**RE: HLP Endodontics, 10429 Lagrima Del Oro NE
Grading and Drainage Plan
Engineer's Stamp Dated 6-03-15 (File: F21-D063)**

**RE: Revised Grading Plan (F-21D063)
HLP Endodontics
Albuquerque, New Mexico**

RE: HLP Endodontics, 10429 Lagrima Del Oro NE
Grading and Drainage Plan
Engineer's Stamp Dated 4-30-15 (File: F21-D063)

6/3/15 DAVID SOULE P.E. #14522	10429 LAGRIMA DE ORO DENTAL OFFICE	DRAWN BY DEM
	GRADING AND DRAINAGE PLAN	DATE 4-14-15
	 1808 CENTRAL AVENUE SUITE 201 ALBUQUERQUE, NM 87106 (505) 872-0088	SHEET # 1 of 2 JOB # XXXXX

BIO SWALE DETAIL
NTS

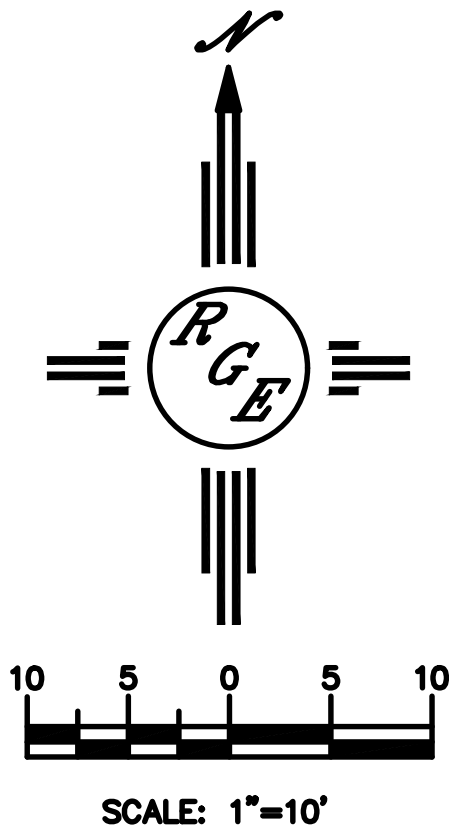
6) Call out depth of 4-6" cobble within the bioswale.

5. Provide spot elevations and slopes for bio swales, label on the plan.
We have added spot and the detail has the side slopes, we had labeled on the plan.

10429 LAGRIMA DE ORO DENTAL OFFICE DRAINAGE PLAN	DRAWN BY: DEM	SHEET # 1 of 2
		DATE: 4-14-15	JOB # XXXXX

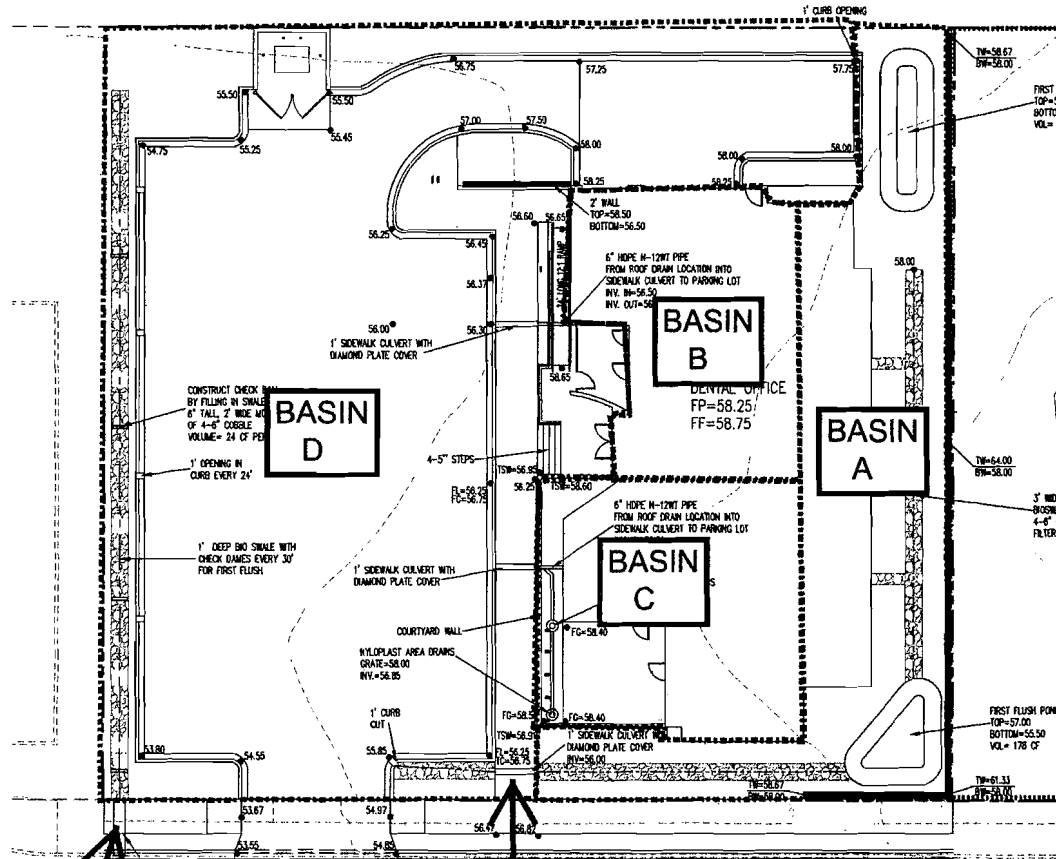
- 1) The swale along the west property line is listed as 1 foot deep with a 6-inch check dam. The middle elevation shown only has a difference in elevation of 0.5 feet between berm and flowline. The invert elevations for the sidewalk culverts also appear to be 30 feet too low from what the elevations are intended to be. Revise as needed, and provide slope of swale as applicable. On cross-section A-A, it would be helpful to show the one foot depth and the 6-inch check dams that are installed every 30 feet. If the check dams are 30 feet apart, label them as such. Also provide the flowline elevations at each of the curb cuts along the west edge of the parking lot. Show the relationship between the curb cut elevation and depth of swale to ensure drainage to swale. Provide riprap for the short distance from the curb cut to the rock swale.

- 2) Reference COA Standard Drawing 2236 for the construction of the sidewalk culvert.
- 3) Approximately 10% of the site drains to the first flush ponds on the east side as indicated by the roof drainage boundary. An insufficient percentage of the first flush volume is provided along the west side even though this is where the vast majority of the site drains. Is there opportunity to provide first flush volumes within the landscaped areas at the northwest and southwest corners of the site?

- 4) Where it says "Volume – 24 cf per dam", add language indicating that this is for the "first flush", and provide the total volume for the first flush within this area.

- 5) On cross-section A-A along the west property boundary, the slope to the west of the berm be called out as 3:1 since it is right along the property boundary without protection.
